SERVICE PROCEDURE

25513
October, 2025

SUBJECT: SAFETY RECALL

**Battery Interconnects in certain 2026 International®
MV™ Series trucks built 3/3/2025 thru 6/11/2025 with
25" Battery Boxes.**

Figure 1. Battery Positioning

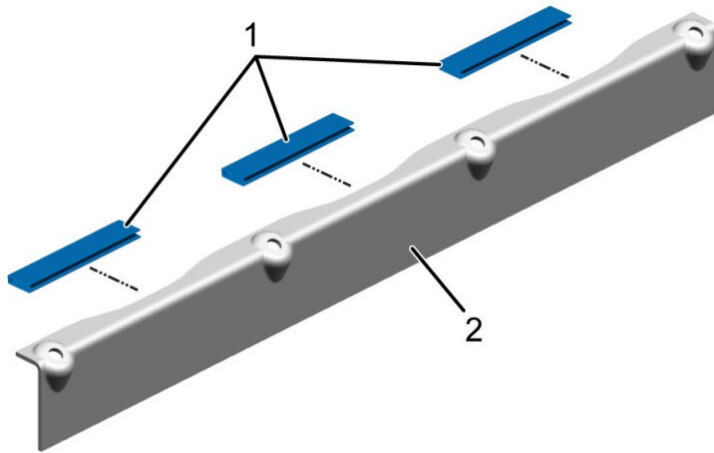
Manufacturing variation can allow for contact between battery interconnect cable with auxiliary stud and hold down bracket.

When contact between these components occurs, a short circuit can develop which may generate excessive heat, which can result in a fire, increasing the risk of property damage or personal injury to the operator.

8. Loosen battery hold down (Figure 1, Item 1).
9. Position vehicle batteries to allow battery interconnect cable to be in straightest line as possible between each battery and as far as possible away from battery hold down (Figure 1, Item 1).
10. Install J-bolt (Figure 1, Item 2) between each battery.
